AURIX™ TC36x errata sheet

Marking/Step: (E)ES-AA, AA

About this document

Figure 1 Message buffer transfer from Message RAM to OBF

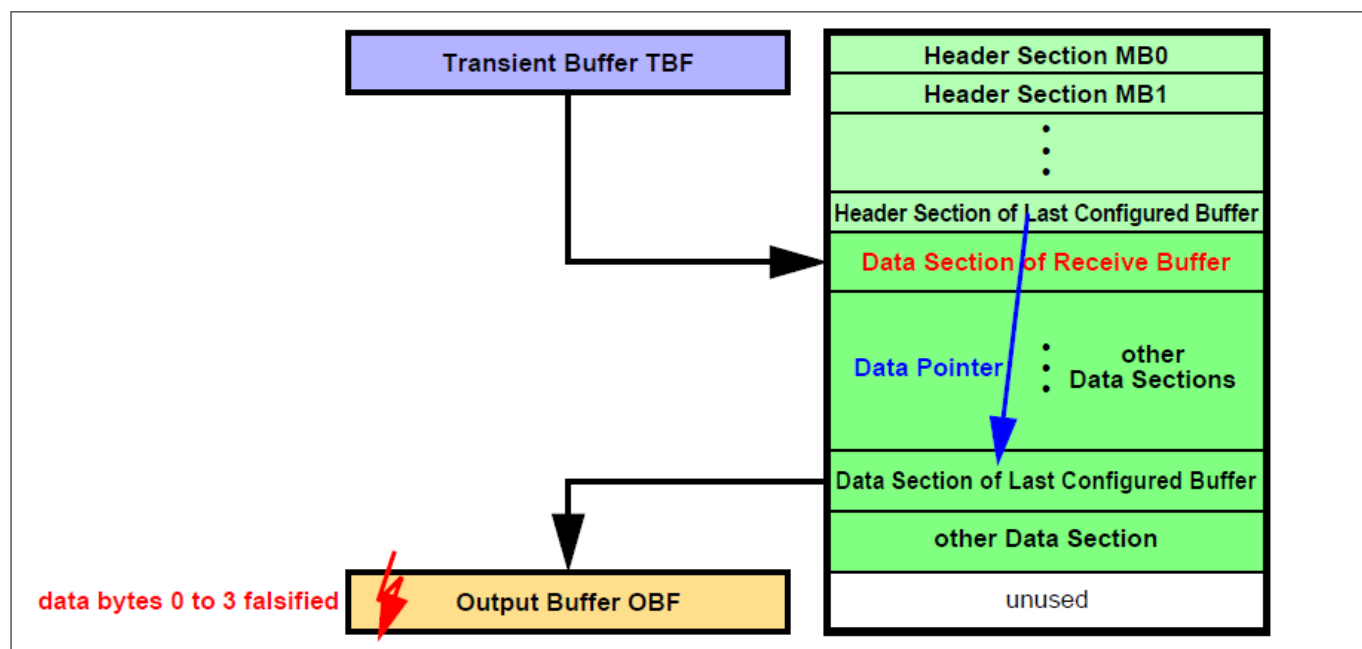
a) When a message is transferred from the Last Configured Buffer in the Message RAM to the OBF and PLC = 127 it may happen, that at the end of the transfer the OBF word on address 00h (payload data bytes 0 to 3) is overwritten with unexpected data (see [Figure 1](#))

Ensure that the Data Section directly following the Header Partition is assigned to a transmit buffer.

Figure 2 Message buffer transfer from IBF to Message RAM

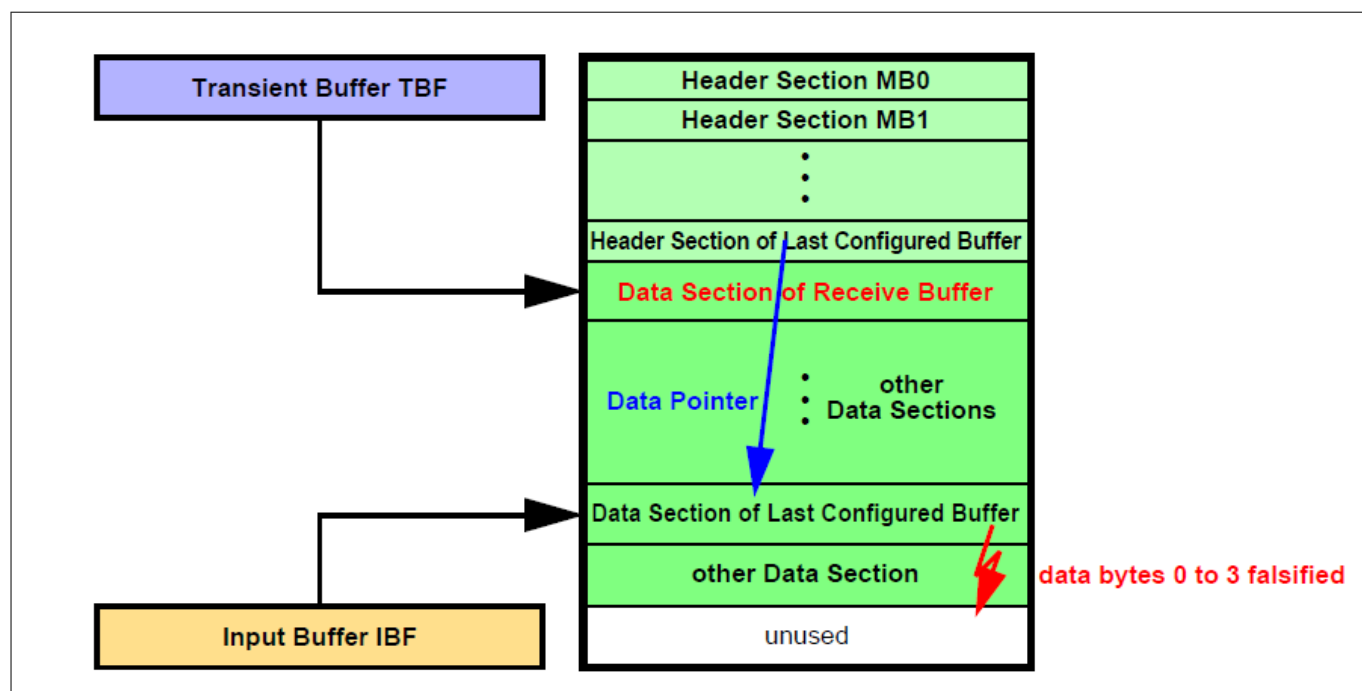
b) When a message is transferred from IBF to the Last Configured Buffer in the Message RAM, it may happen, that at the end of the transfer of the Data Section one additional write access overwrites the following word, which may be the first word of another message's Data Section in the Message RAM (see [Figure 2](#))

Figure 6 Critical MCS AEI master scenario

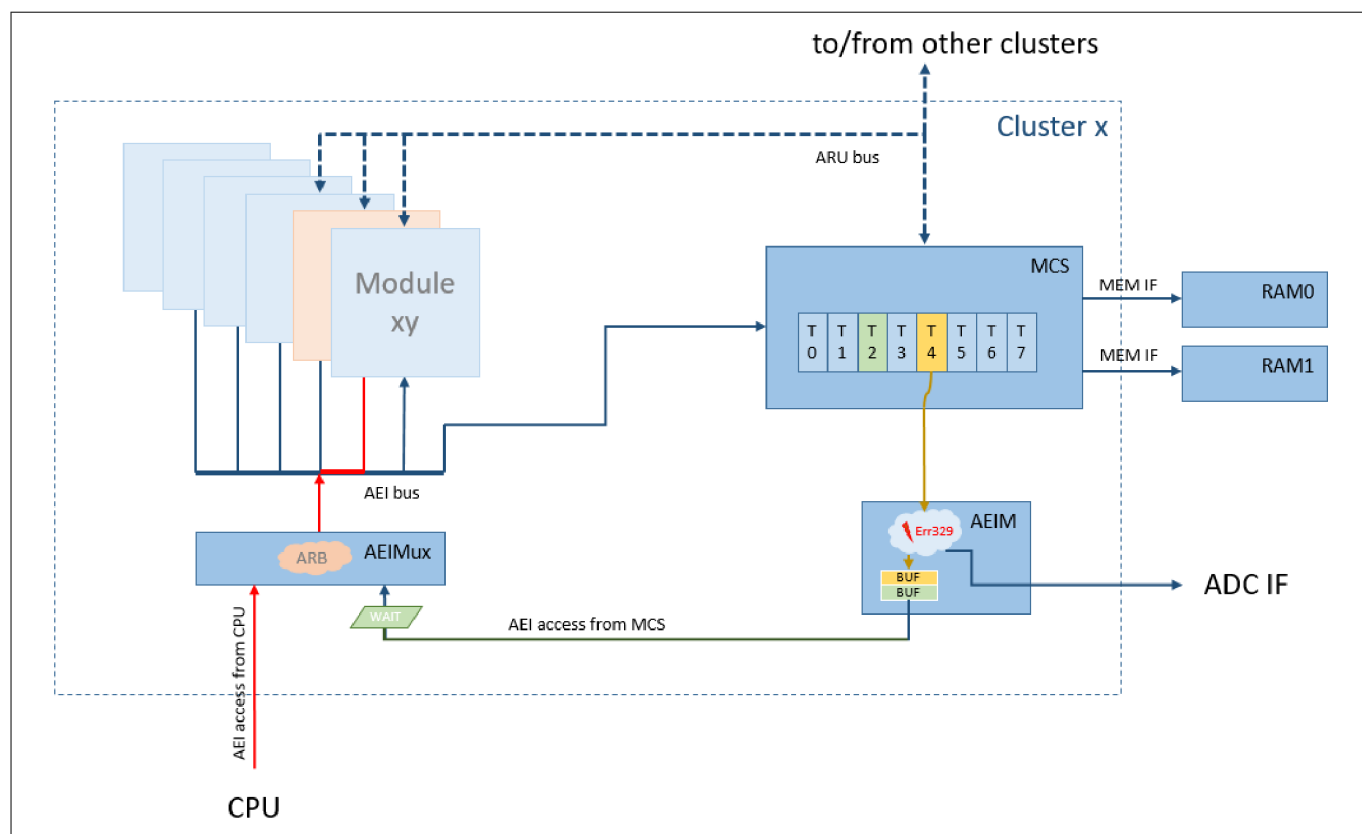
In [Figure 6](#), a potential risk for the occurrence of problem GTM_AI.329 is illustrated. Here the first buffer of the AEIM (green) is still waiting for the access to the AEI bus while a second AEI bus access from MCS arrives at the AEIM (yellow access path). Under certain, but for the user unpredictable timing conditions, this second AEI bus access arriving at the AEIM can trigger the misbehavior described in problem GTM_AI.329.

The workarounds described in the 'Workaround' section will ensure that not more than one AEIM buffer will be filled and therefore the occurrence of problem GTM_AI.329 is avoided. All workarounds have been tested and proven correct.

Figure 7 MCS token mechanism

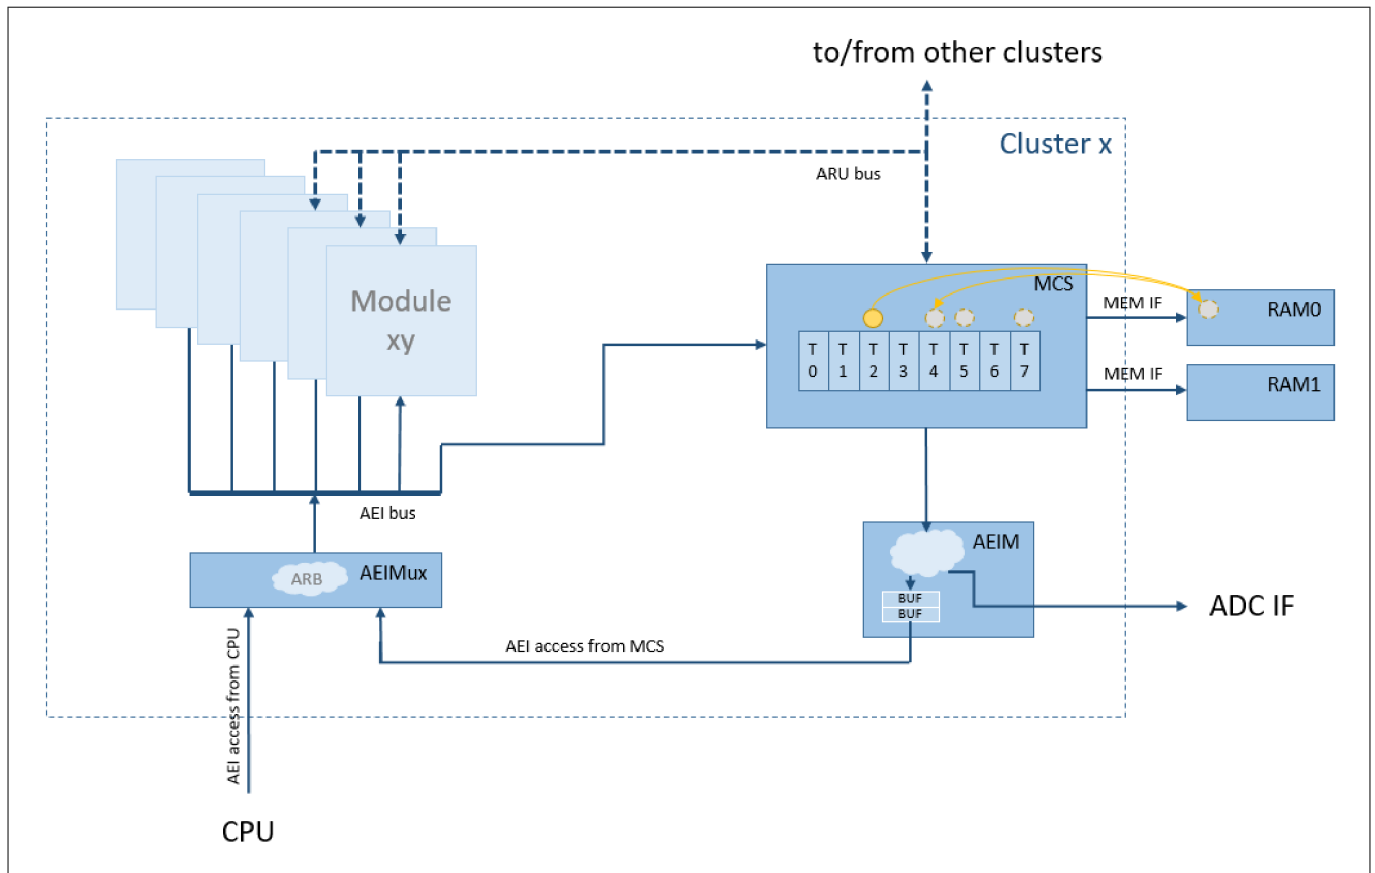
In case multiple MCS channels want to use the AEI master port for AEI or ADC communication, establish a mechanism that ensures that only one channel uses the AEI master at a time (e.g. exchange a token between channels or use trigger registers to hand over the AEI master port ownership between MCS channels).

An application note (AN020 – MCS Mutex implementation) describing a token exchange mechanism between MCS threads is available at Bosch. Such a token mechanism allows multiple MCS threads to safely access the AEI bus system by exchanging an AEI bus access token via MCS memory.

Figure 8 TBU value evaluation MCS against other modules. Red (past) and green (future).

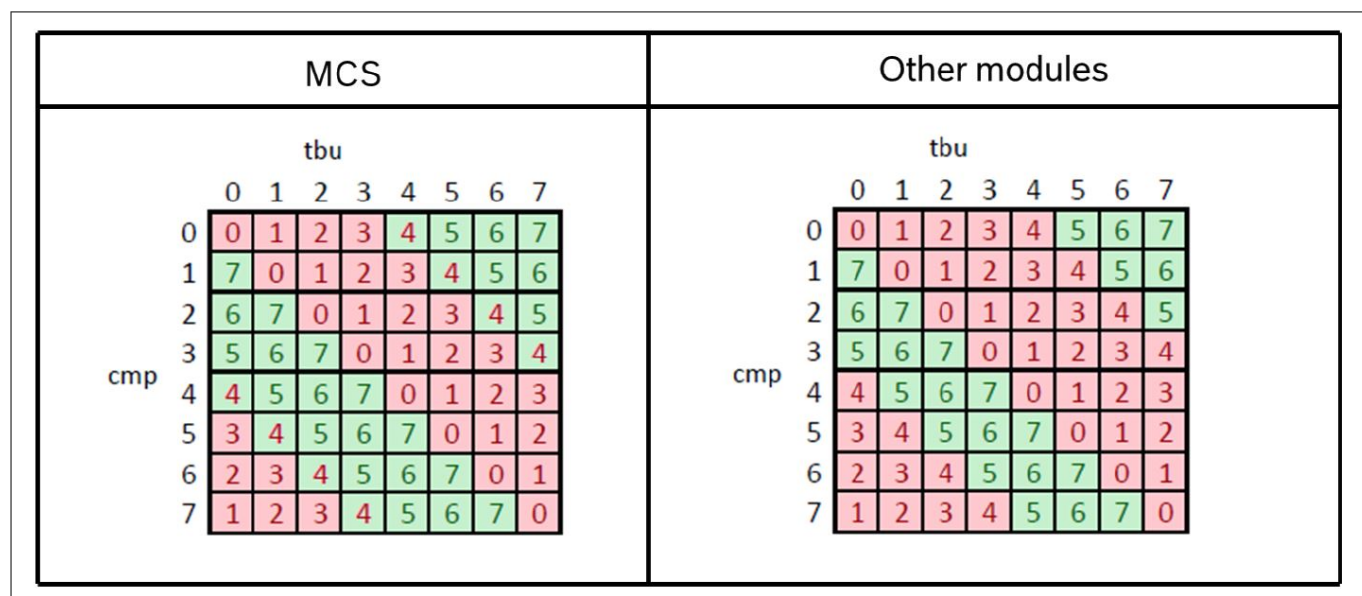
With the revised specification of GTM 4.1 it was revealed that the implementation for the WUCE instruction is not correct for the boundaries. The implementation of the WUCE instruction has an inverted behavior for both boundaries between future and past.

Figure 12 Timing of LVDS TX interface command sending in relation to IRQ.IFCFS

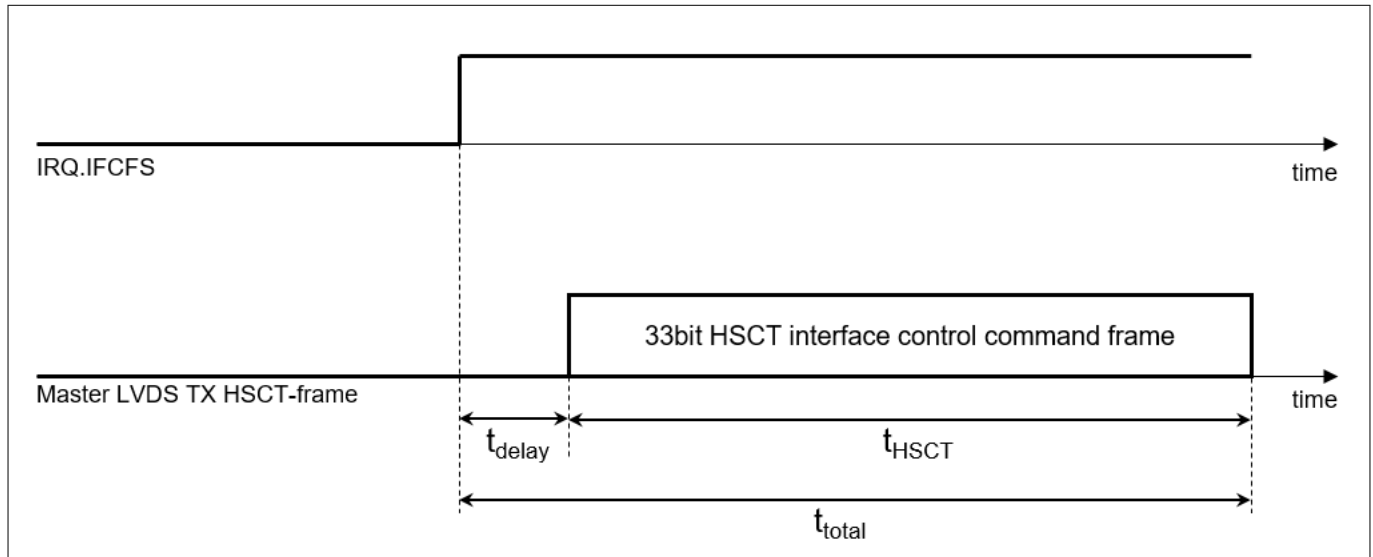
the user might falsely assume that also the actual sending on the LVDS TX port has already occurred once the IRQ.IFCFS flag is set, which is not true.

Instead the timing shown in the following figure applies.

Figure 13 Package Outlines LQFP-176 for TC36x

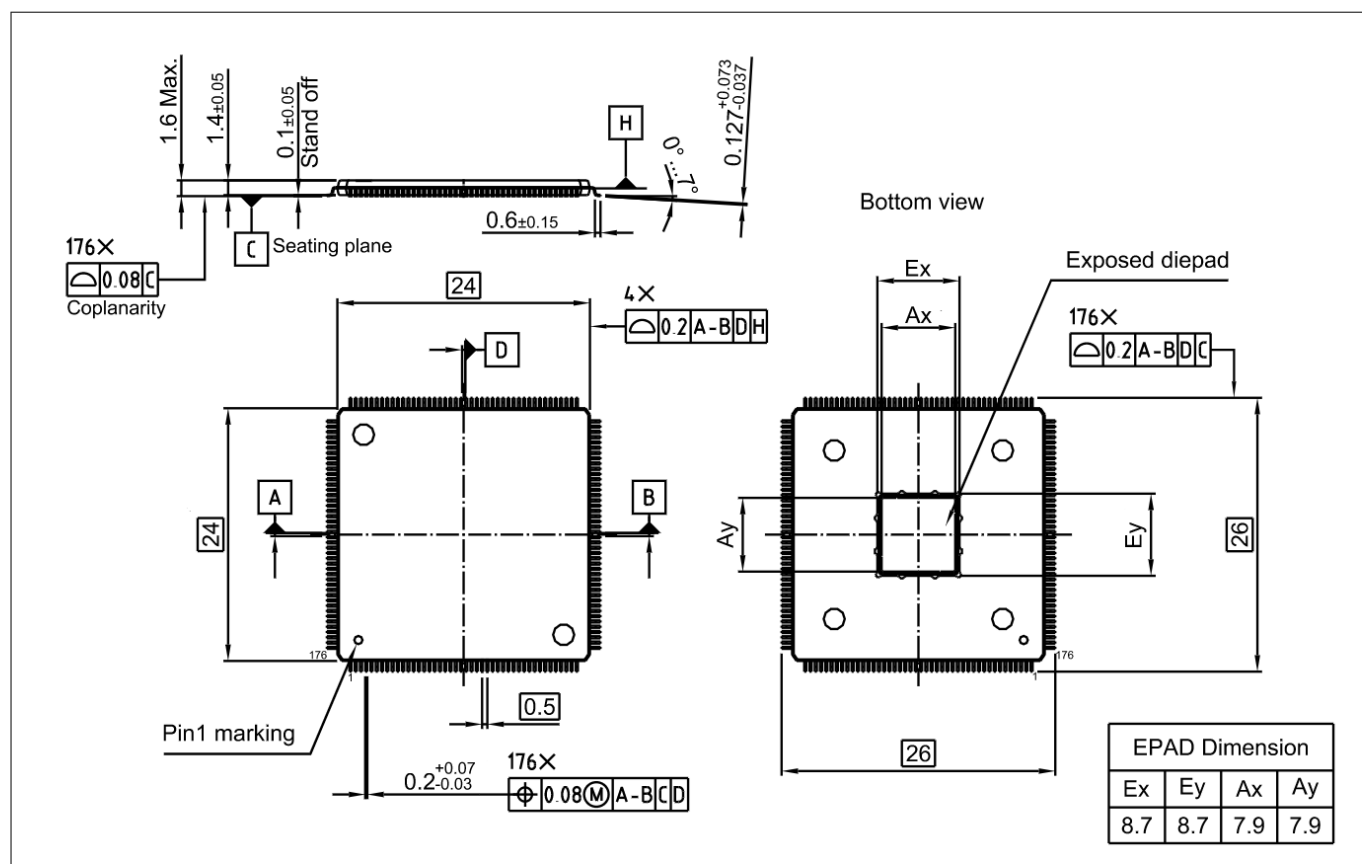
The dimensions for the exposed diepads have been corrected and included into the respective figures. This replaces the corresponding information in erratum text module PADS_TC.P013 (Exposed pad dimensions for QFP packages - Correction to TC36x Data Sheet V1.1).

Note: For the exposed diepad of the LQFP-176 package of the TC36x, structural corner protrusions have to be considered for purposes of system design and integration with a maximum boundary of 9.4 mm.

This information shall substitute the corresponding information in the TC36x AA-step Data Sheet V1.1.

Figure 14 Package Outlines LQFP-144 for TC36x

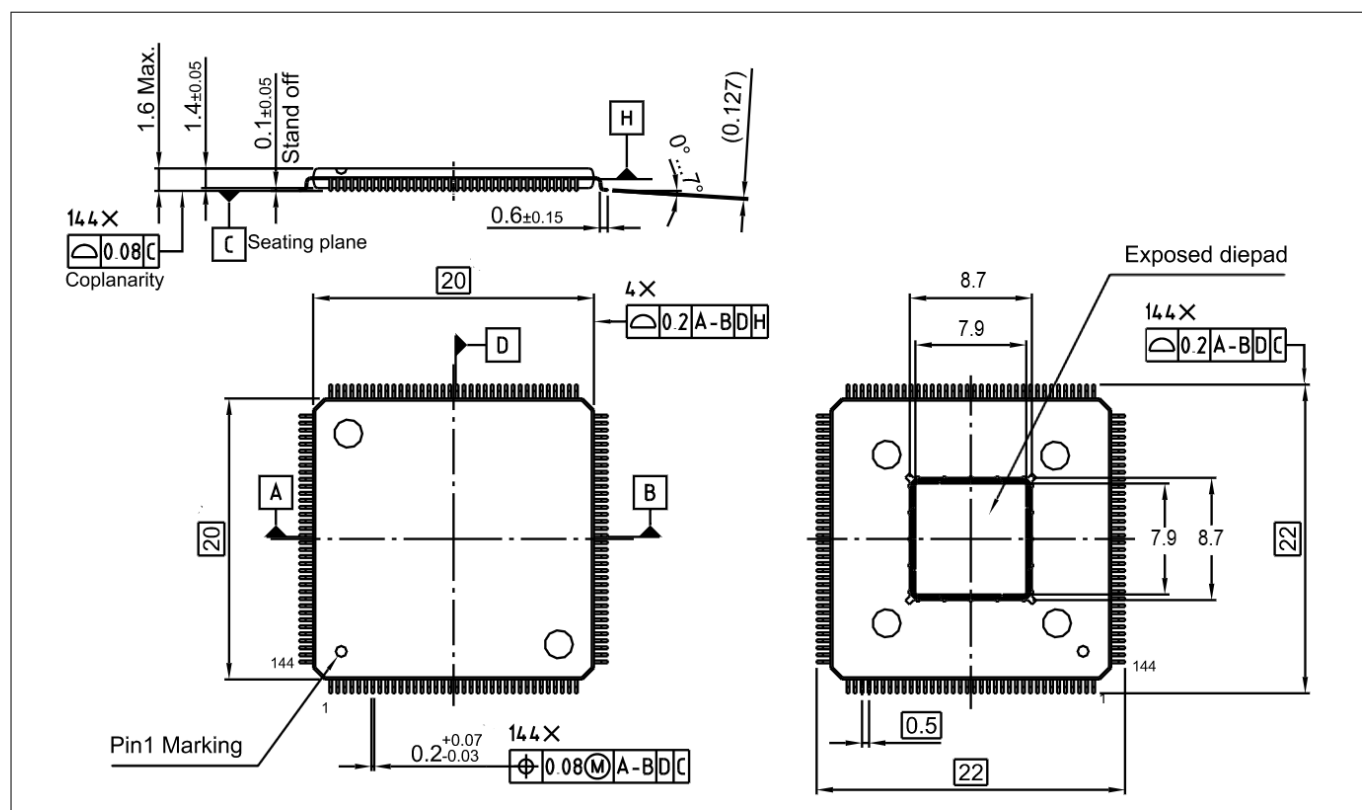
Note: For the exposed diepad of the LQFP-144 package of the TC36x, structural corner protrusions have to be considered for purposes of system design and integration with a maximum boundary of 9.4 mm.

Figure 15 Package Outlines TQFP-144 for TC36x

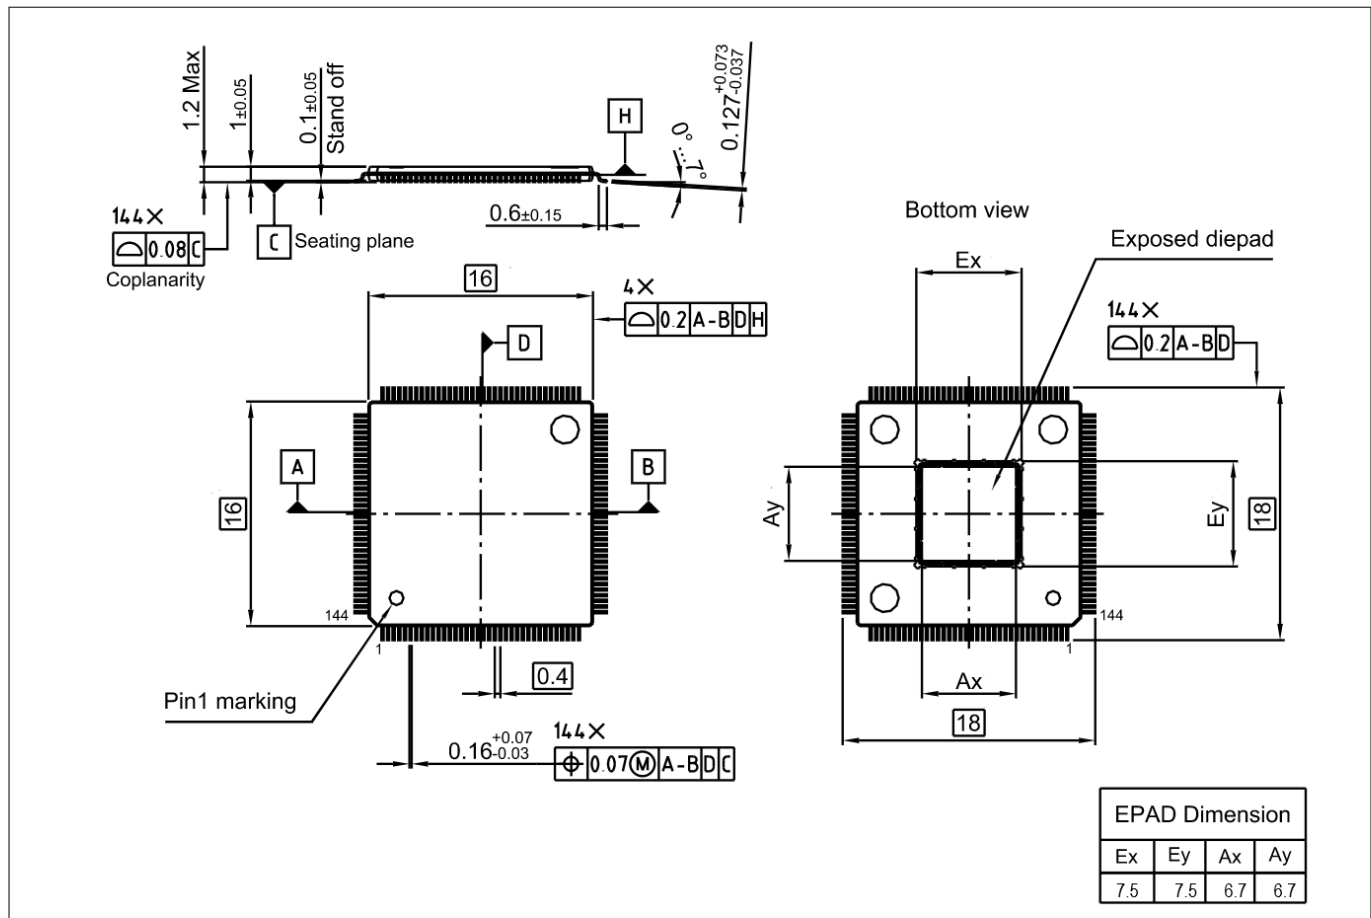
Note: For the exposed diepad of the TQFP-144 package of the TC36x, structural corner protrusions have to be considered for purposes of system design and integration with a maximum boundary of 8.0 mm.
